**PLANNING COMMISSION AGENDA**  
**City Commission Chambers - City Hall**  
625 Center Street, Oregon City, Oregon 97045  
**November 8, 2010 at 7:00 p.m.**

TO:	Planning Commission
FROM:	Tony Konkol, Community Development Director
PRESENTER:	Pete Walter, Planner
SUBJECT:	Master Development Plan for the redevelopment of the Hilltop Mall. Planning Files CP 10-01, DP 10-02 and WR 10-03.
Agenda Heading: Public Hearing	
Approved by: Tony Konkol, Community Development Director

**QUASI-JUDICIAL LAND USE DECISION (TYPE III)**  
**Staff Report and Recommendation to the Planning Commission**

**FILE NO.:** CP 10-01: Concept (General) Development Plan<sup>1</sup>  
DP 10-02: Detailed Development Plan (Site Plan and Design Review)  
WR 10-03: Natural Resource Overlay District (NROD) Review

Hilltop Mall - Site Plan

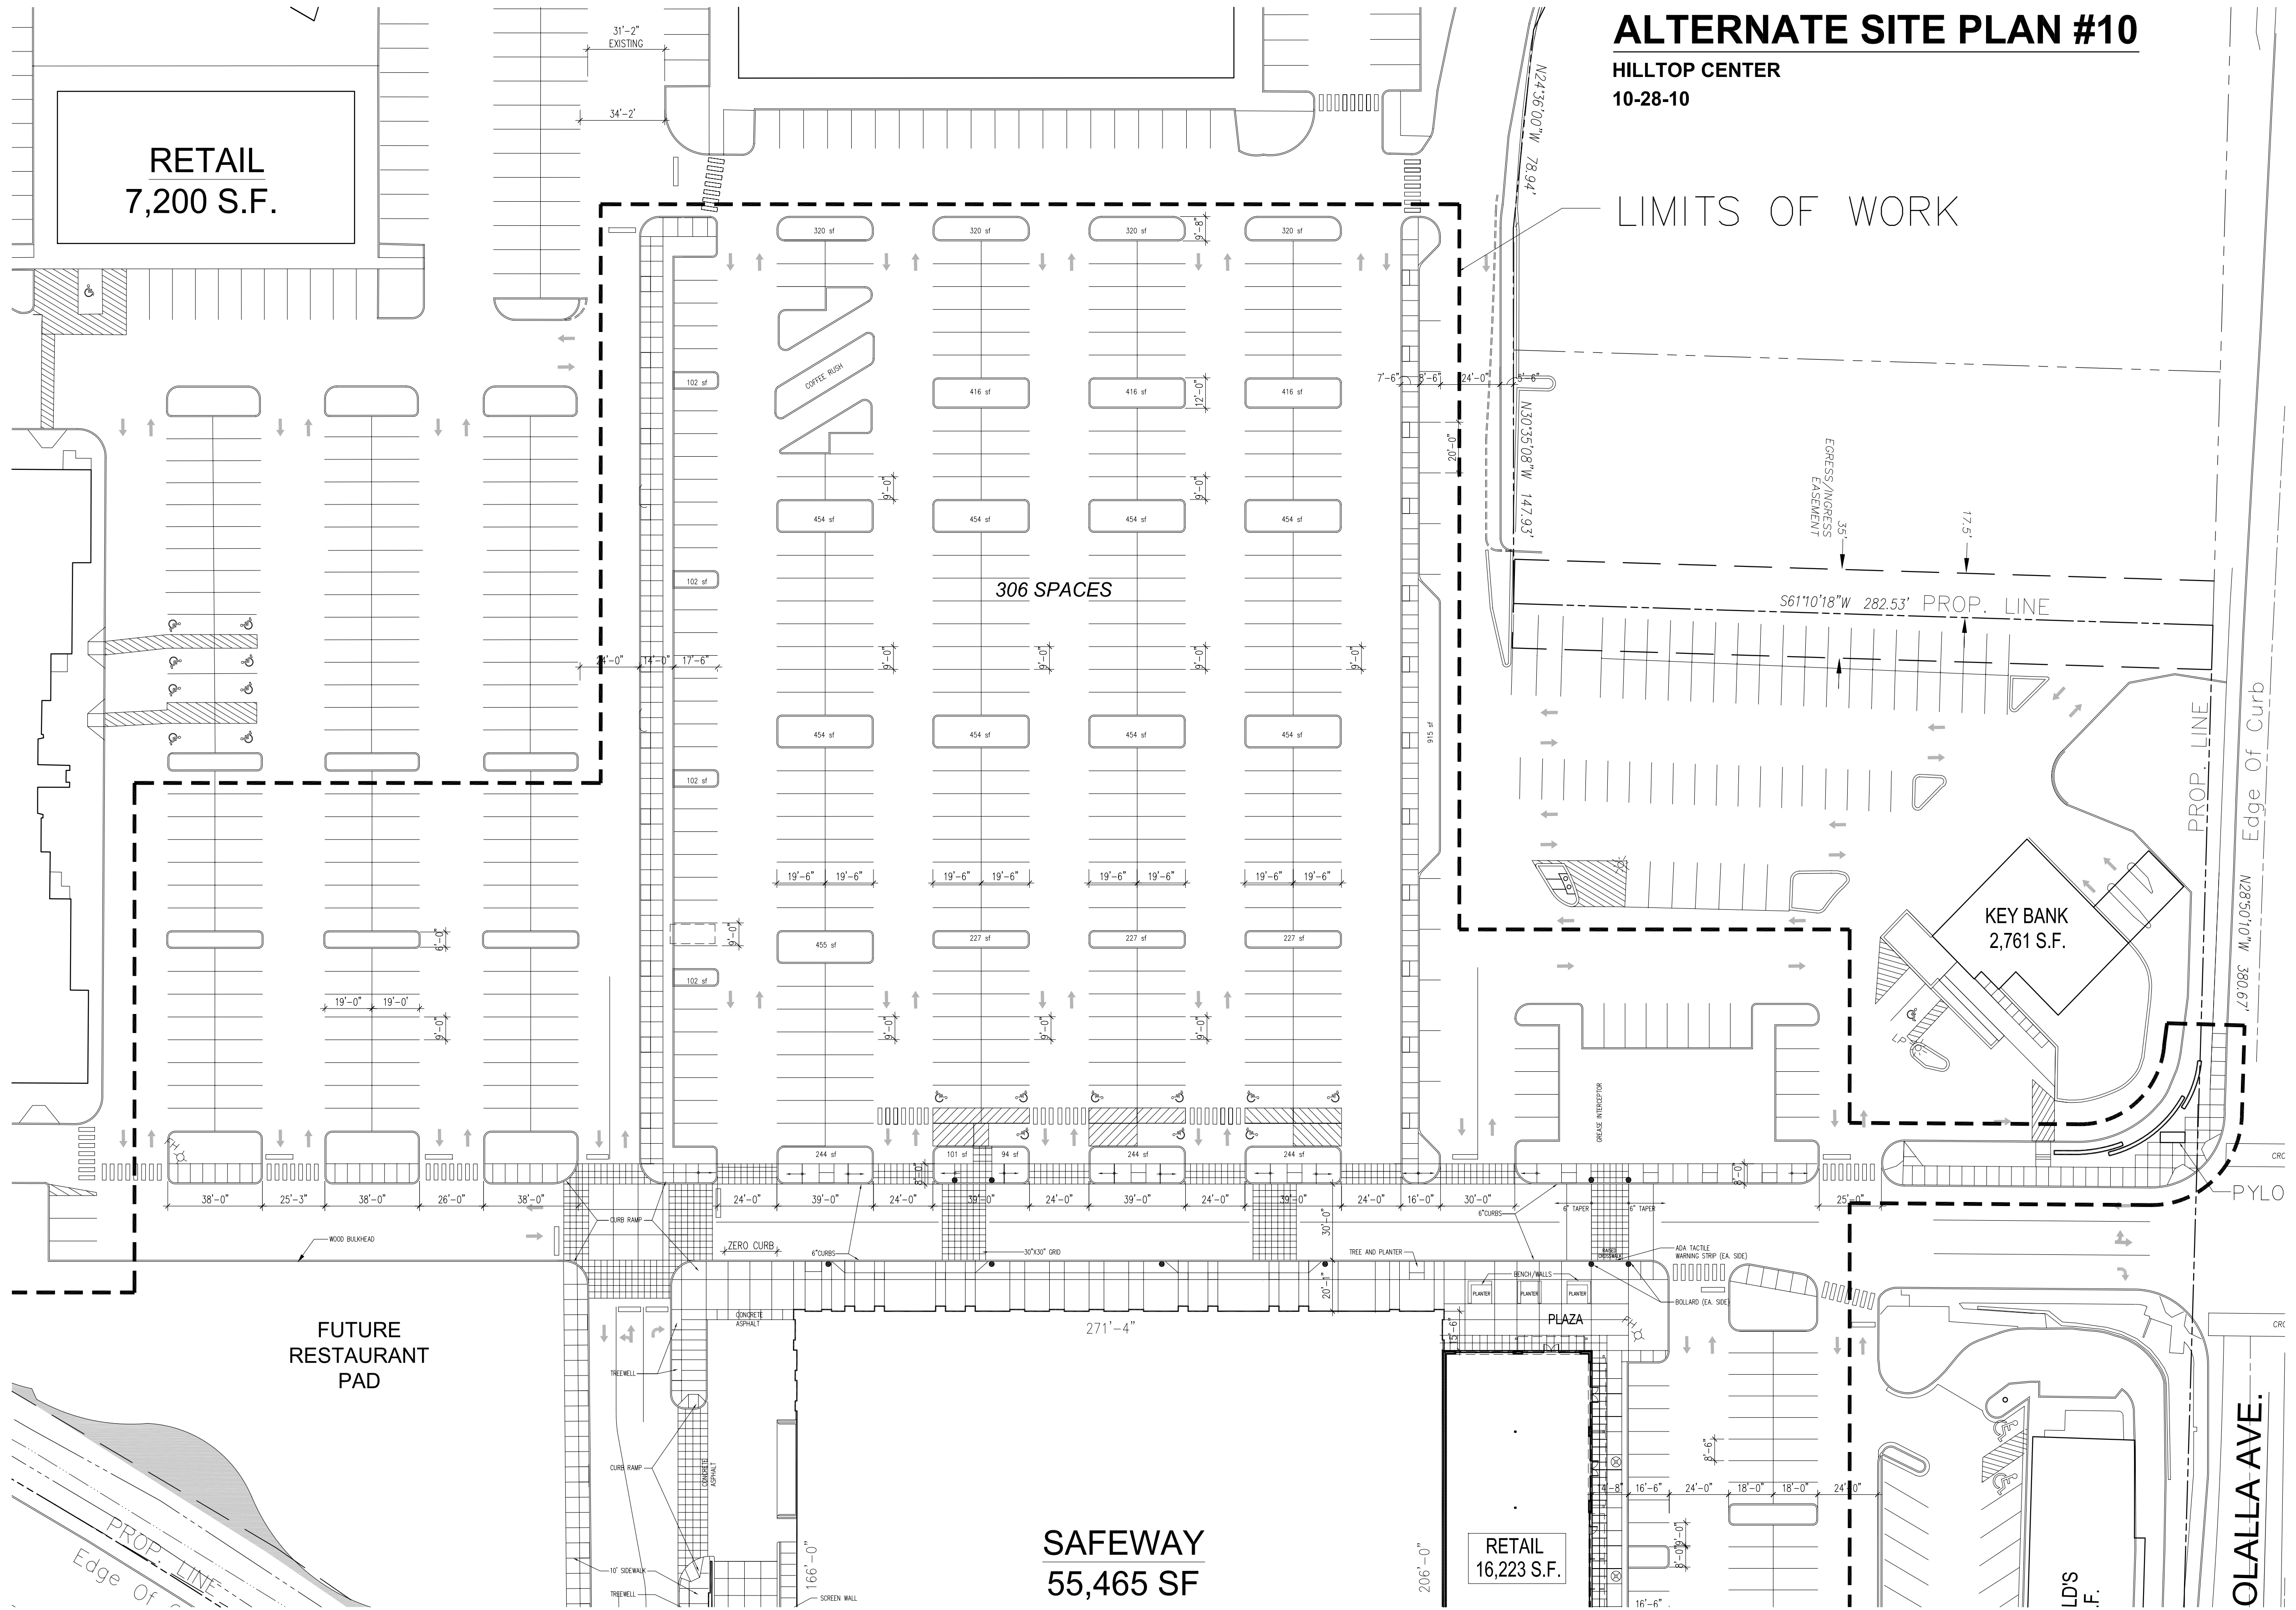
The applicant has provided a phasing plan indicating how the site will be improved to provide the required pedestrian and vehicular access (Exhibit 25). The applicant has revised the parking lot to provide two pathways between the parking lot and the main building (Exhibit 26).

**Finding: Complies with Conditions.** The applicant has provided a revised parking lot plan indicating compliance with this section (Exhibit 26). The applicant shall provide a revised landscaping plan for review and approval by the Community Development Director that incorporate the most recent revisions. **Applicant can assure this standard is met through Condition of Approval 19.**

19. The applicant has provided a revised parking lot plan indicating compliance with this section (Exhibit 26). Prior to occupancy, the applicant shall provide a revised landscaping plan for review and approval by the Community Development Director that incorporate the most recent revisions.

**NORTH ELEVATION - A**  
DATUM ELEVATION = 100'-0"  
(FRONT)

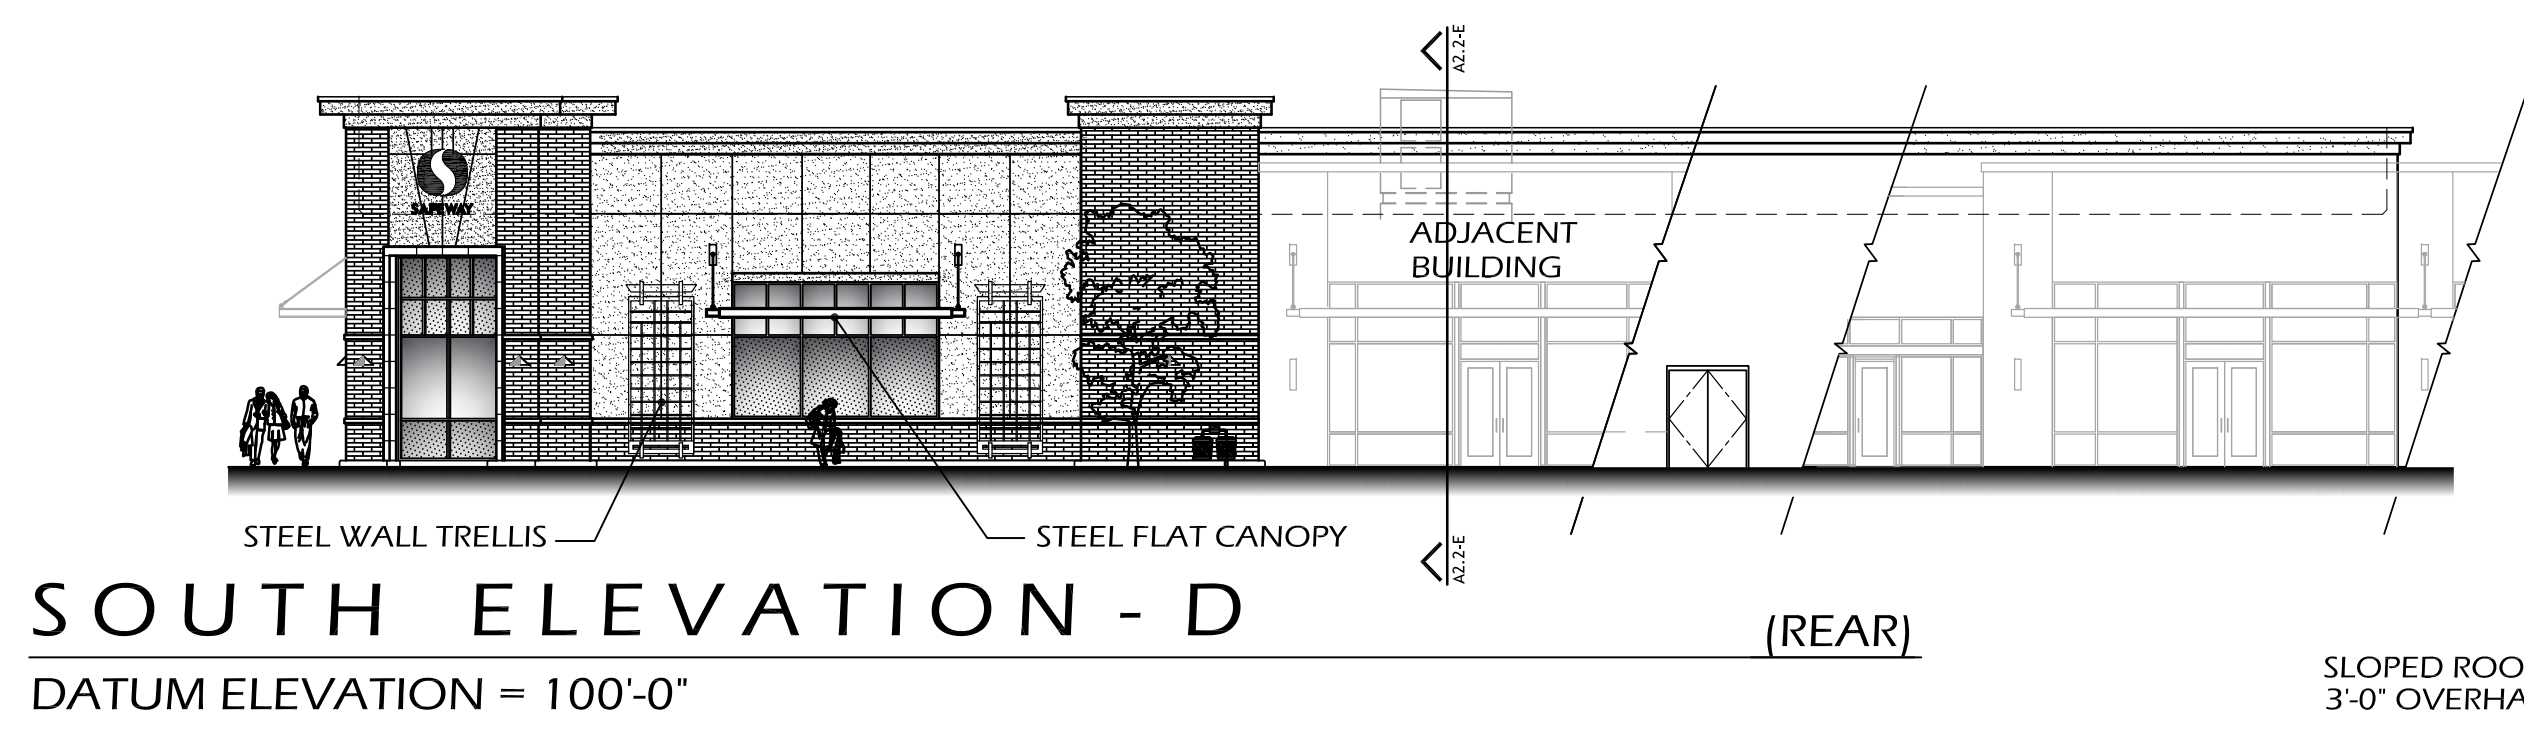
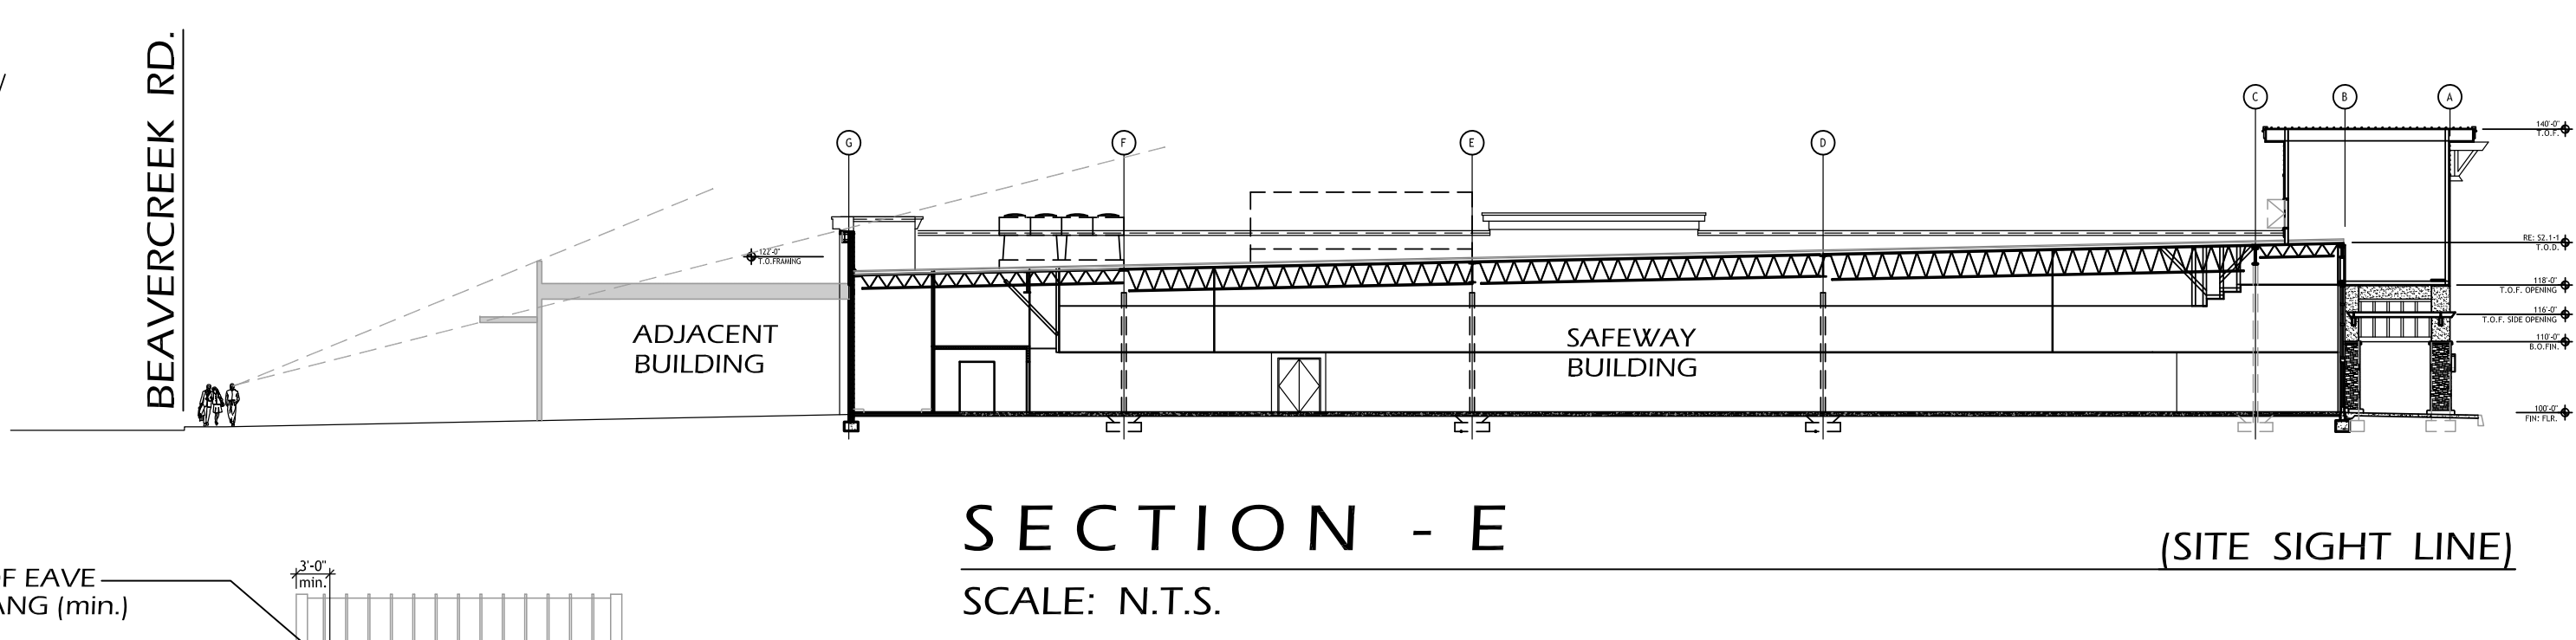
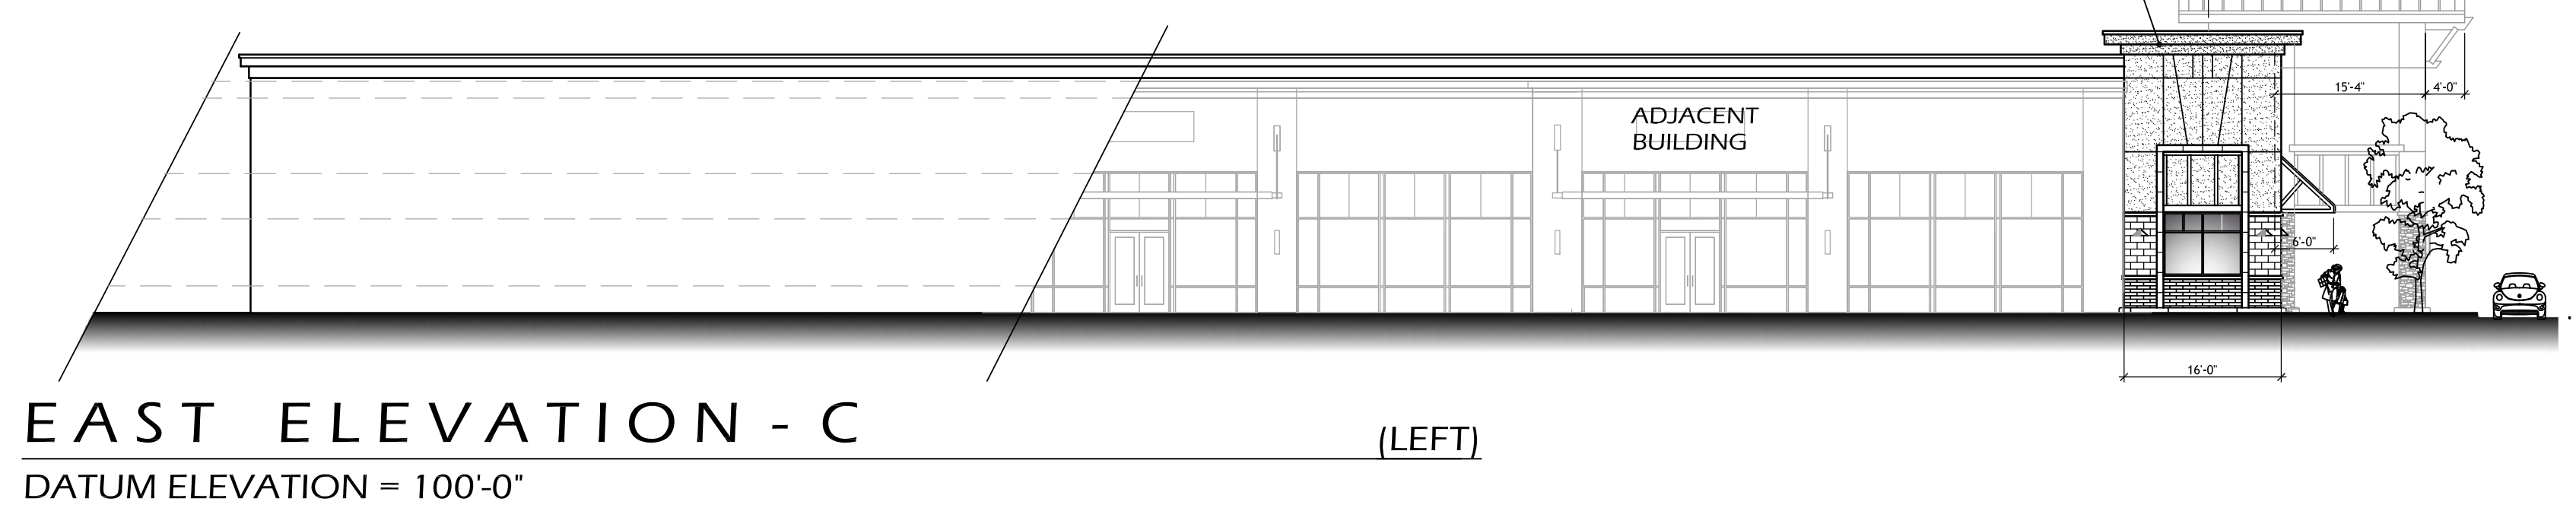
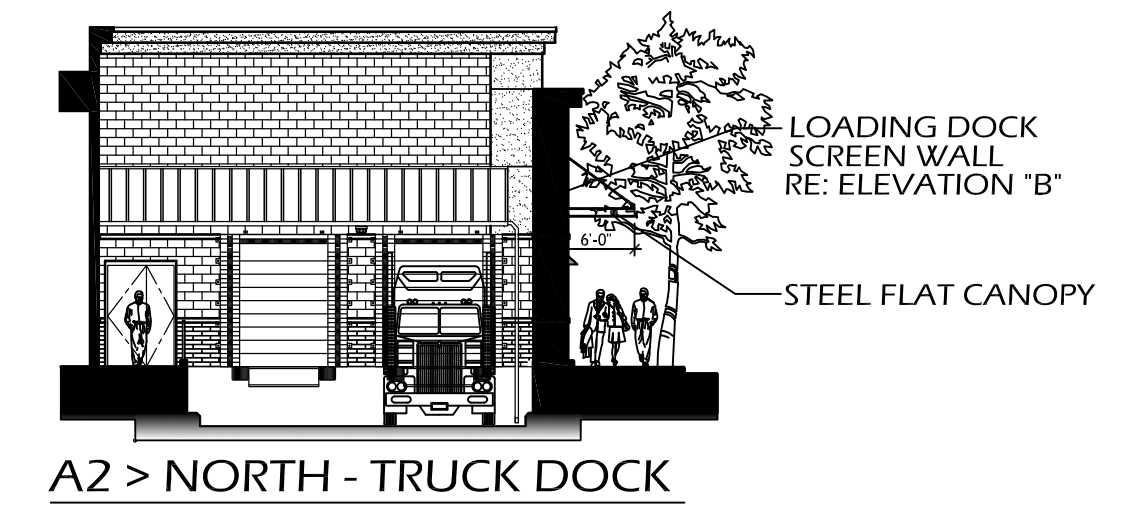
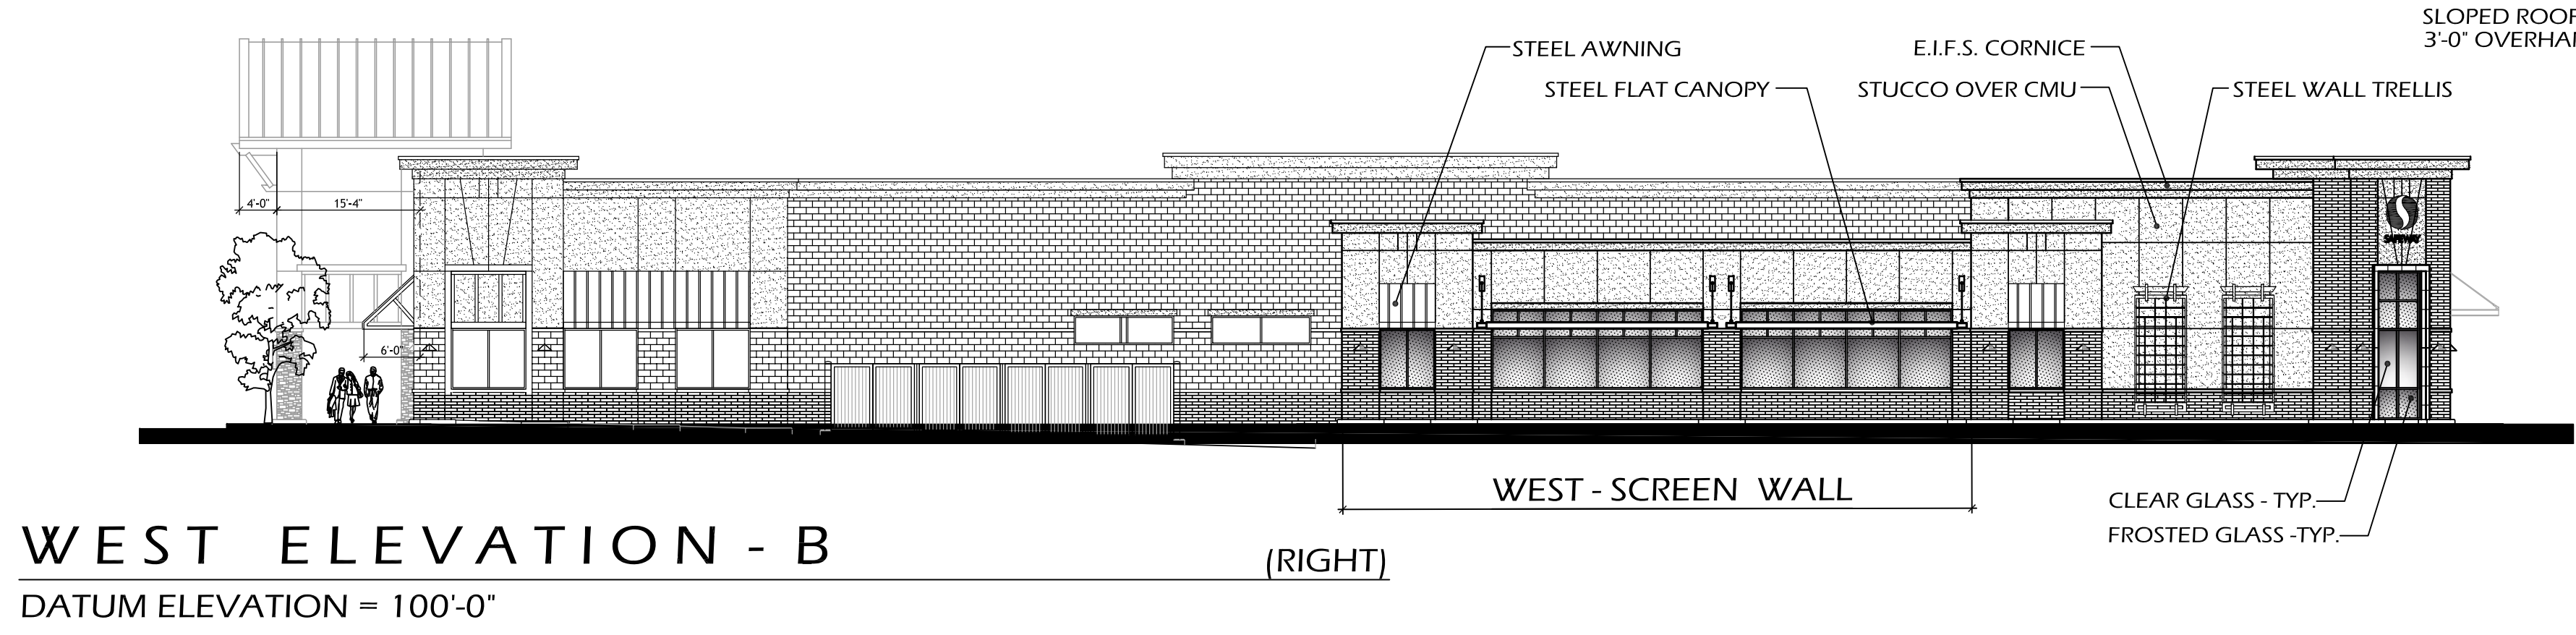
Further in Staffs Text on page 60 staff reviews the Safeway Gables and Eaves which were not shown as being the full 3' per criteria b.

*Regarding overhanging eaves, the gabled roof elements are shown project between 1' to 2.5' beyond the roof canopy, therefore standard (b) of this section has not been met.*

The elevations are in compliance under the other criteria but Safeway is proposing that the major overhangs will comply with the 3' eave length. Please see KJD2 Elevation 2.2 that highlights the eaves that comply with the 3' criteria.
